ANNUAL UPDATE REPORT - 1980
ON THE
CONSTRUCTION SETTLEMENT MONITORING PROGRAM
FOR
NORTH ANNA POWER STATION - UNITS 3 AND 4
VIRGINIA ELECTRIC AND POWER COMPANY

February 29, 1980

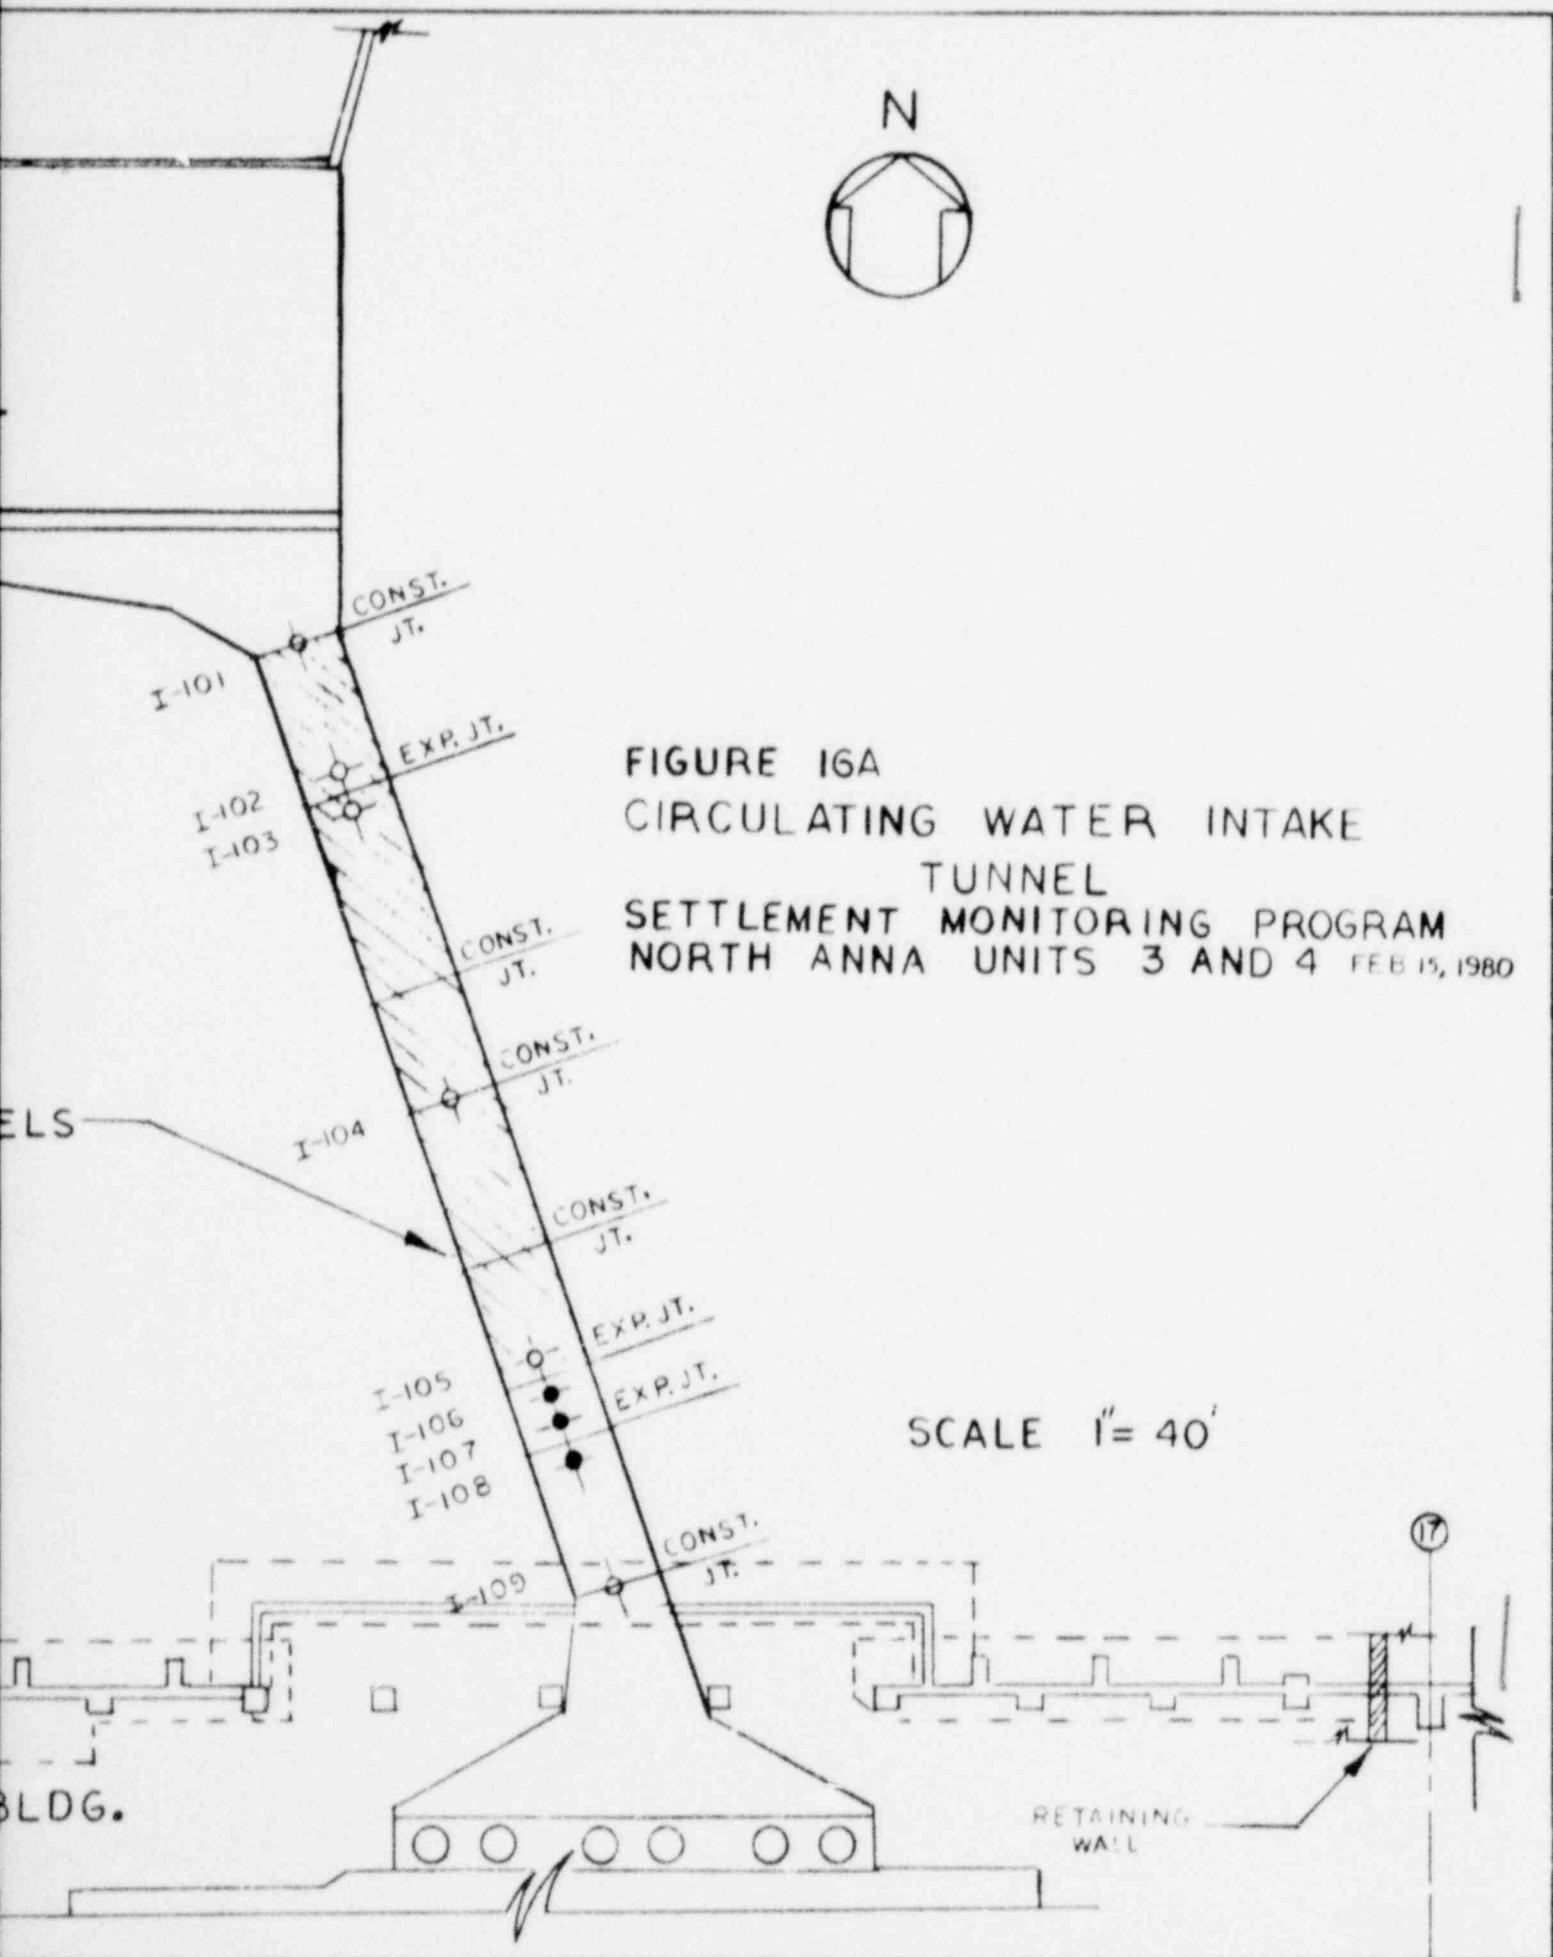
Figures 16 and 18 (circulating water intake and discharge tunnels respectively) of the April 2, 1979 report have been revised to correct the number of existing settlement monitoring points. The revised figures are numbered 16A and 18A. The changes consist of the following:

1. Figure 16A - Circulating Water Intake Tunnel: Settlement monitoring point I-105 is an existing point established in December, 1977.
2. Figure 18A - Circulating Water Discharge Tunnel: Settlement monitoring points D-3, D-4, and D-5, shown as installed points in the April 2, 1979 report, have not been installed. Point locations D-3 and D-4 have been eliminated due to access problems. Point D-5 will be installed when construction of the circulating water discharge tunnel is resumed.
